Final Set, Jefferson Village Phase II  
(Bulletin 6)

JEFFERSON VILLAGE

TYPICAL PAVEMENT CROSS SECTIONS

HOR. SCALE: NO SCALE  
VER. SCALE: NO SCALE  
DATE: 3-27-00  
JOB NO.: DE99011  
FILE NO.: DE9911X1  
SHEET NO.: P-0.2

JEFFERSON VILLAGE  
Neighborhood Development Corporation  
FREUD AVE. STA. 90+00 TO STA. 101+50  
PAVING - PLAN & PROFILE

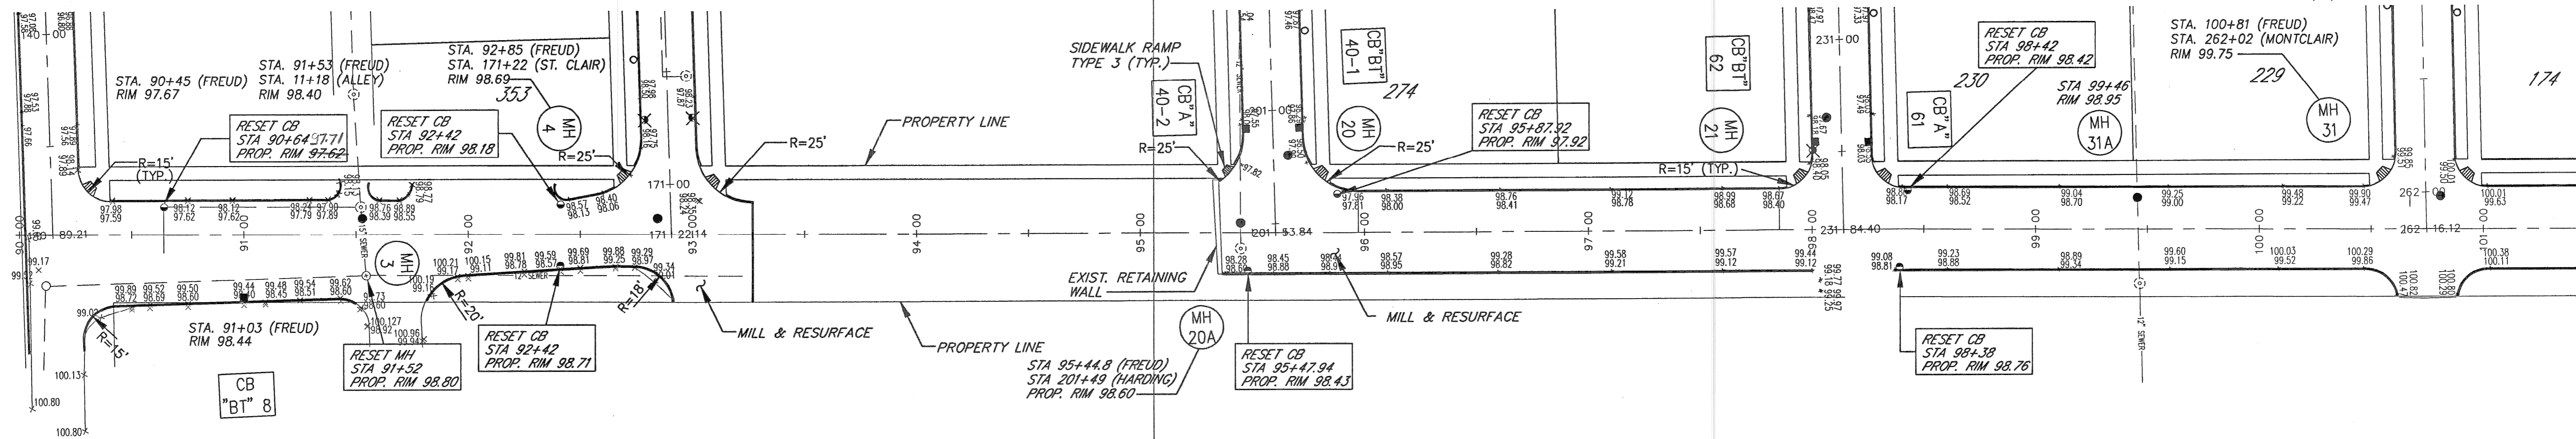
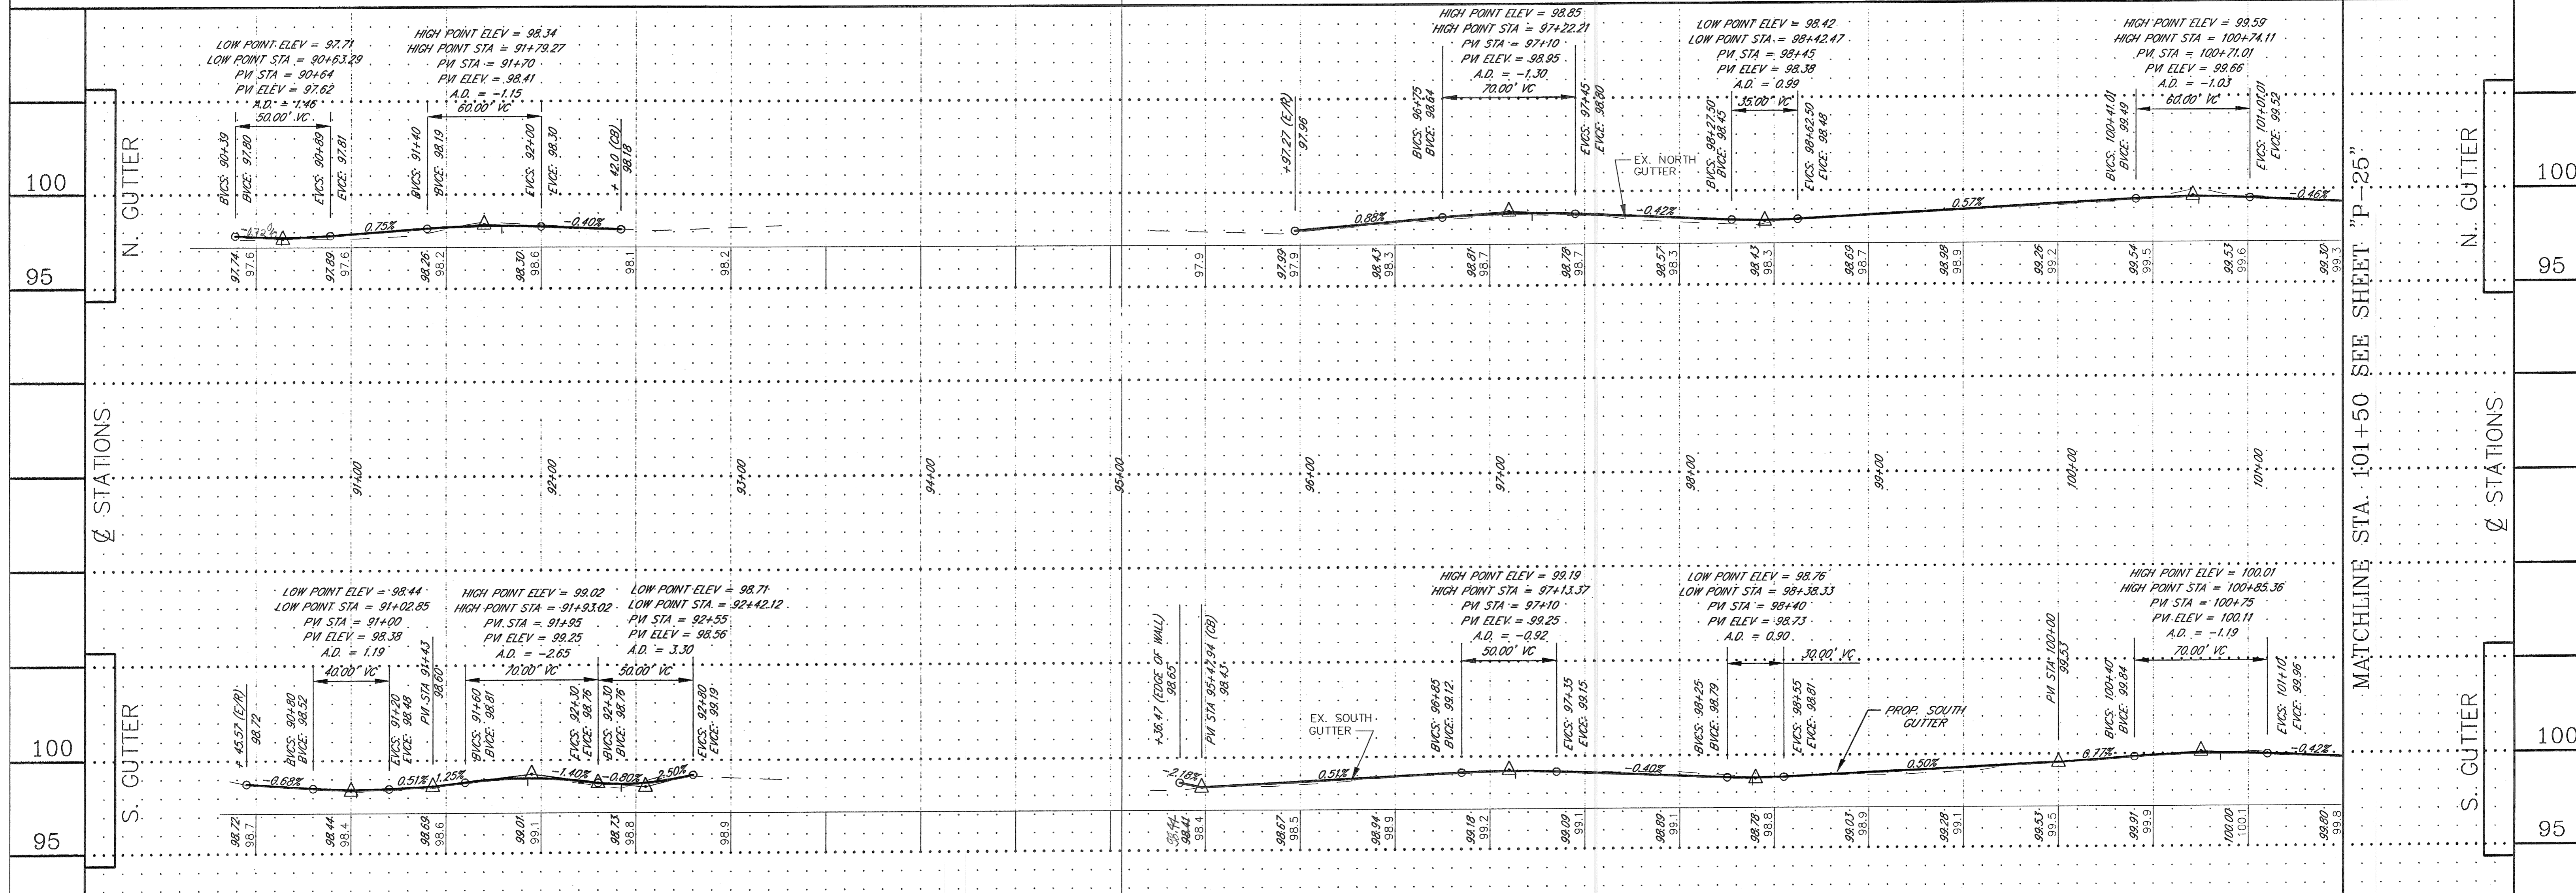
HARDING AVE. TO STA. 101+50 (N&S)  
REMOVE CURB 1,200 LIN. FT. PLACE  
SEPARATE TYPE CURB 1,200 LIN. FT.

NEW STREET  
PAVING - PLAN & PROFILE

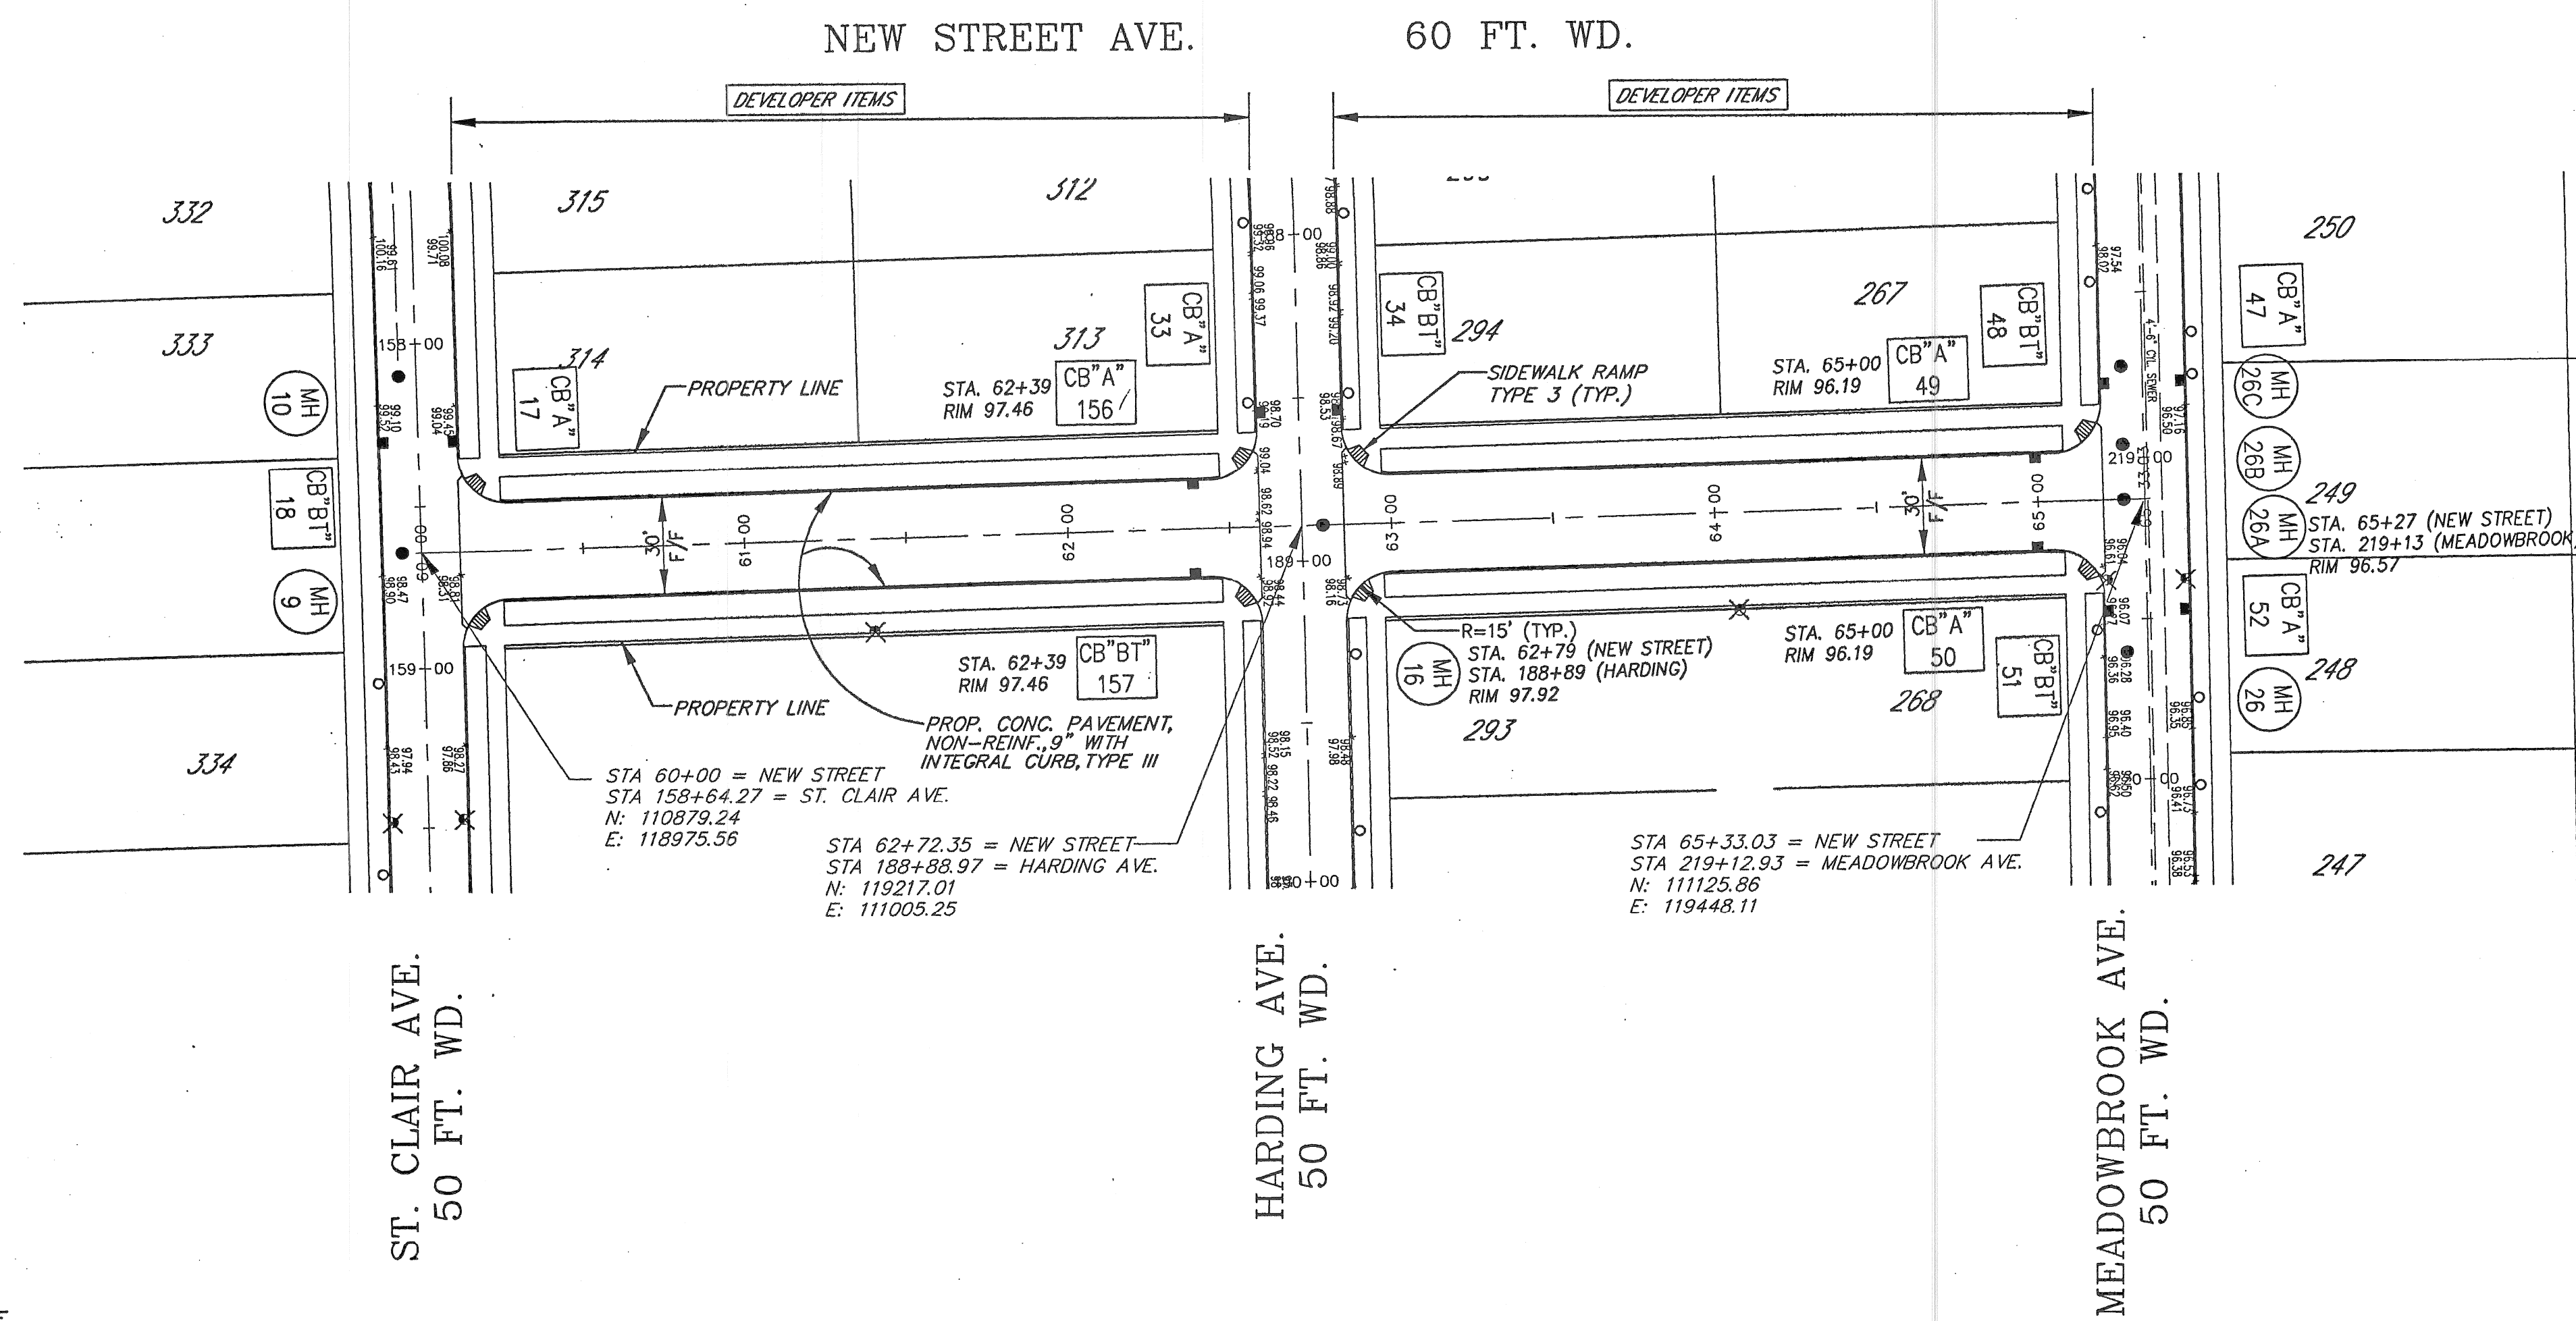
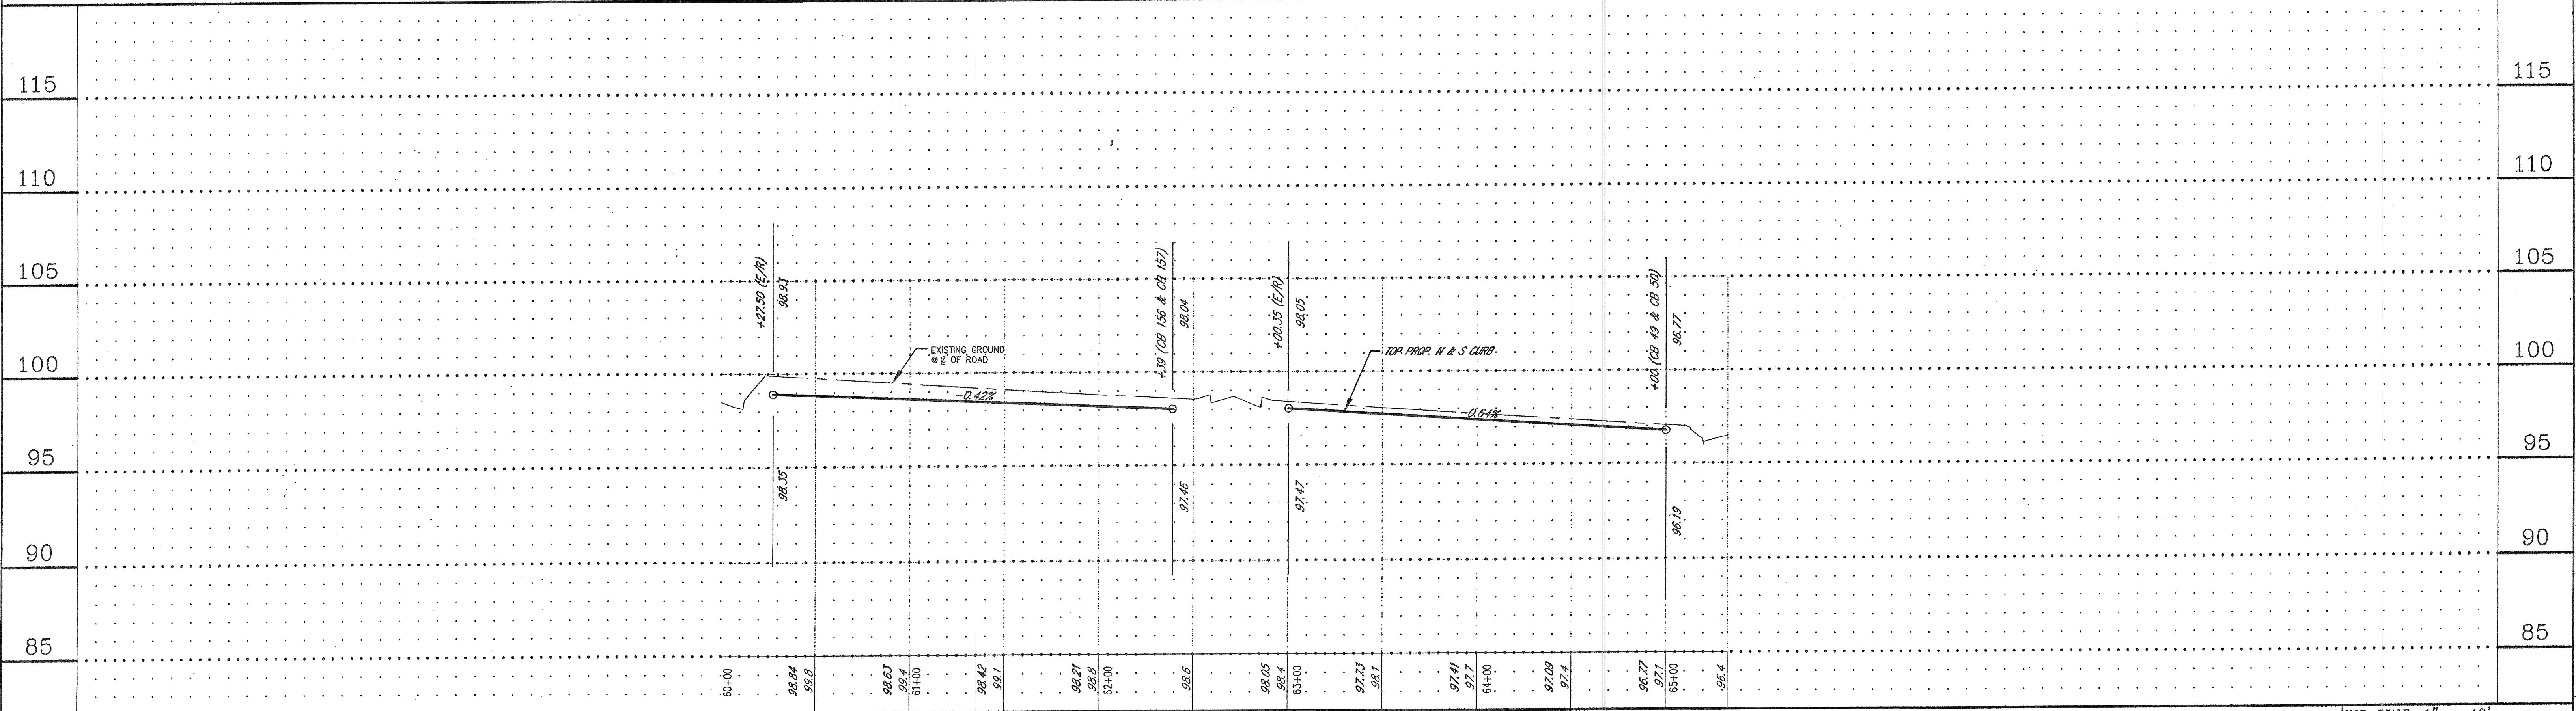
**NOTE:**  
 THE TYPE OF CURB WAS CHANGED FROM 7" HIGH STRAIGHT FACE TO 4" HIGH ROLLED CURB AFTER THE PREPARATION OF THE PAVING PLANS AND PROFILES (EXCEPTING FOR FREUD, MARQUETTE AND NEW STREET BETWEEN BENITEAU AND ST. JEAN). THE PAVEMENT ELEVATIONS AS SHOWN ON THE INTERSECTION DETAILS SHEETS SHALL BE MAINTAINED. ONLY THE TOP OF CURB ELEVATIONS SHALL BE DROPPED BY 0.25" (3"). THIS SHALL BE ACHIEVED BY SUBTRACTING 0.25" (3") FROM THE TOP OF CURB ELEVATIONS SHOWN ON THE PROFILES.
